Re: February 11, 2009 San Diego Regional Board Meeting, Item 6 - Poseidon Resources
       Corporation, Proposed Carlsbad Desalination Project (Order No. R9-2006-0065, NPDES
       No. CA0109223

APF Calculations for Carlsbad Desalination Project

My comments on the presentation that Dr. Raimondi gave to the CA Coastal Commission (CCC) on the mitigation for the Carlsbad Desalination Project are provided below and presented by slide number. The comments focus on his calculations, which encompass slides 7–20.

Understanding uncertainty of compensation through mitigation using APF (direct impacts only)

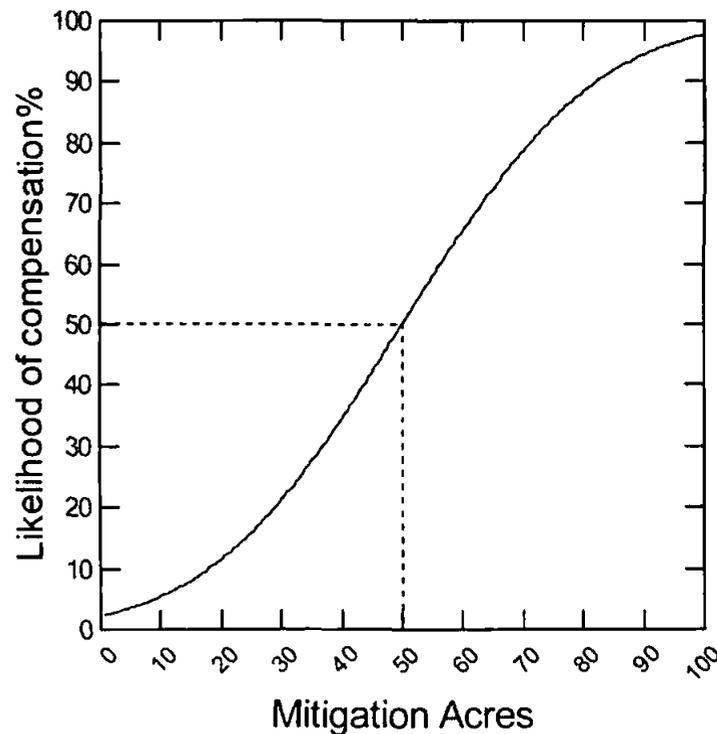
The calculations on this slide are derived directly from standard statistical theory. The graph shown in the slide is the cumulative probability function for a set of normally distributed data with a mean of 50 and a given standard error. The curve in the slide shows the probability on the y-axis that a value less than or equal to the corresponding APF value on the x-axis would occur from a sample of normally distributed data with the given mean and standard error. Translated into confidence intervals, the distribution represents the corresponding values that would define the upper and lower limits for a confidence interval based on a given probability level. For example, a 90% confidence interval (5% to 95% on curve) would range from ~10 to 90 acres. Placed into the context of a confidence interval centered on the mean, it is easy to see why the 50% probability level is always the average value since, on average, 50% of the values would be less than or equal to that value. Therefore the y-axis has nothing to do with compensation, it is the probability that the value from a sample of data with the specified mean and standard error is actually 50.

Use of error in calculations

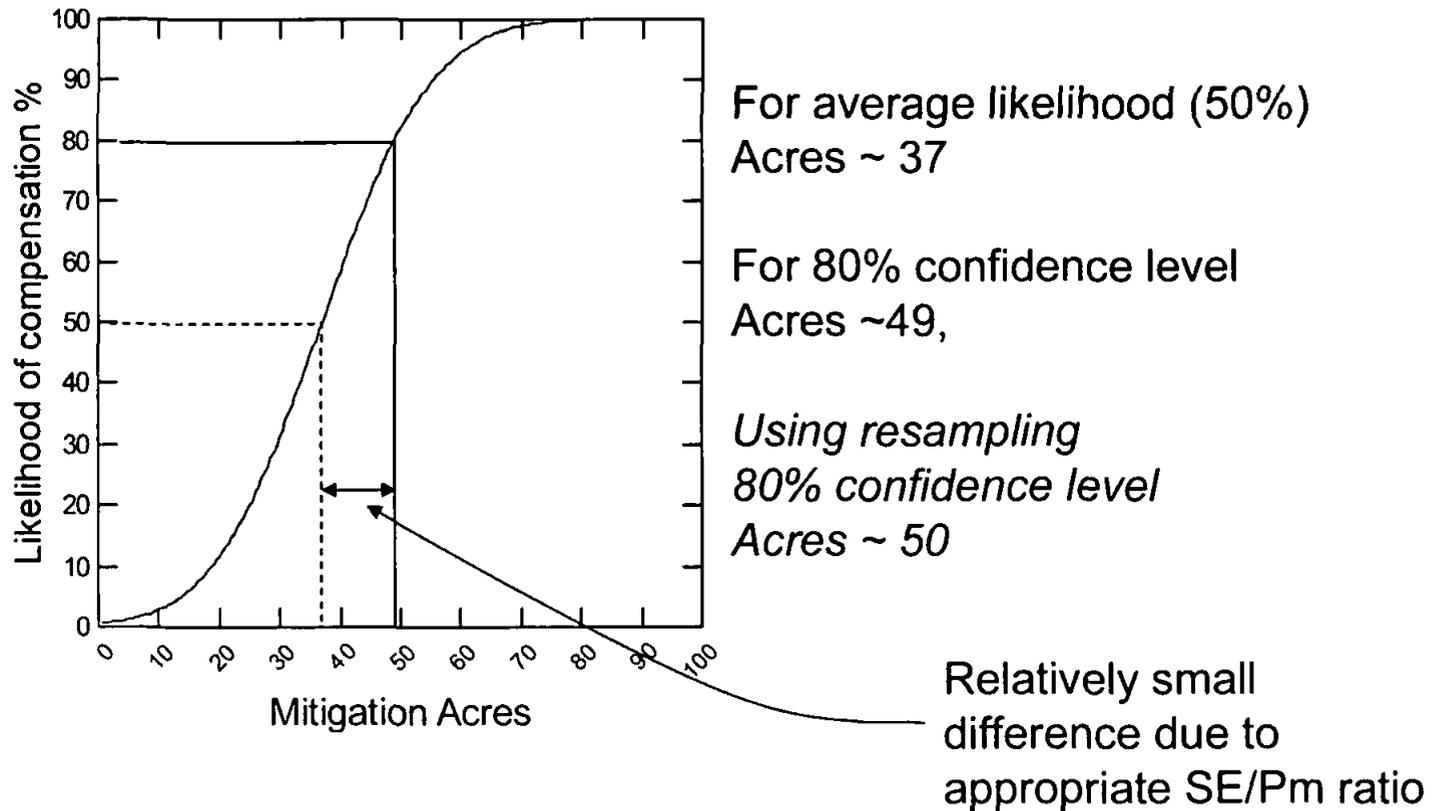
These slides present the various sources of error that could be used in the calculations. Dr. Raimondi uses the standard error in his calculations which he correctly states leads to more conservative (lower) estimates. This is also probably the correct estimate of error to use since the concept here is directly tied to confidence intervals, which are calculated using the standard error. He applies a commonly employed Z-statistic of probability distribution:

– Prob = ZCF ((acres – mean acres)/calculated SE)
– Where ZCF is the normal cumulative function

Uncertainty of compensation through mitigation using APF
Estuarine Species (direct impacts only)
Case 1: using error rate calculated in report (SE dominated by source water concentration of larvae)

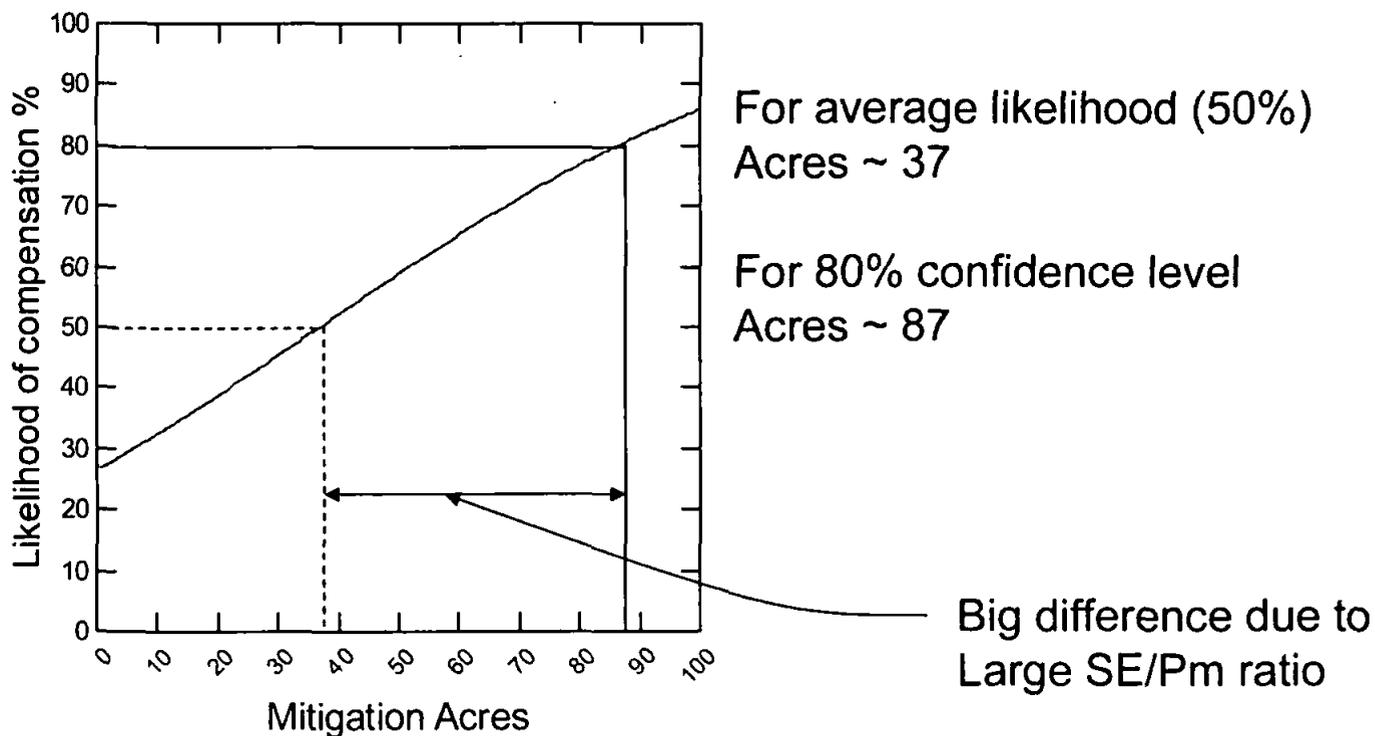
In order to produce the cumulative probability curves used in slides #14 and #15 to calculate the relationship between variance of PM and the number of mitigation acres required for compensation probabilities illustrated in slides 14, 15 and 17, Cases 1, 2 and 3, respectively. The

Figure 2.

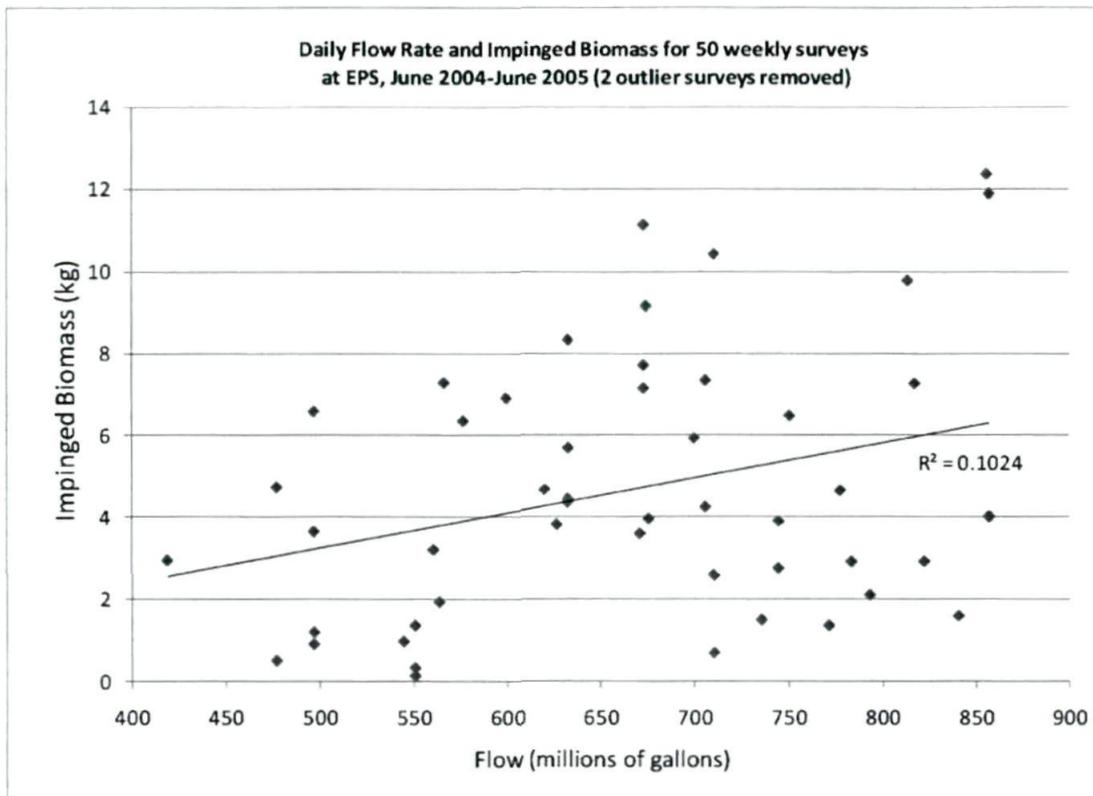
As shown in Figure 2, the sampling period flow rate consistently exceeded the stand-alone desalination plant flow of 304 MGD. Regression of these data resulted in an estimated, average daily impingement effect of 1.56 kg from the desalination plant stand-alone operations at 304 MGD. We found a statistically significant relationship between the impingement effects and flows measured under normal power plant operations that occurred during the June 2004 to June 2005 impingement survey.

It is important to note that 6 of the 13 samples collected for plant intake flows at or below 550 MGD had impingement effect approximately equal to or less than the initially estimated daily impingement effect 0.96 kg/day. Another trend that can be noted in Figure 1 is that the opposite is true for flows above 550 MGD -- the majority of the impingement results are above the average of the curve.

This observation is consistent with nationwide findings on the relationship of intake volume, velocity, and impingement that indicate an impingement threshold at or above a velocity of approximately 2 fps. Below this velocity, impingement effects decline rapidly. The impingement effects continue to dramatically decline as the intake approach velocity nears 0.5 fps and below. In essence, the lower the velocity, the greater the likelihood that fish will be able to navigate away from the intake structure, and avoid impingement. The desalination plant stand-alone operations at 304 MGD will mirror these conditions -- intake approach velocities at the bar racks will be approximately 0.5 fps. Consequently, we expect to observe a velocity-driven impingement reduction effect during stand-alone operations that will result in impingement rates that are below the statistical projection of 1.56 kg/d, and possibly below 1.0 kg/d.
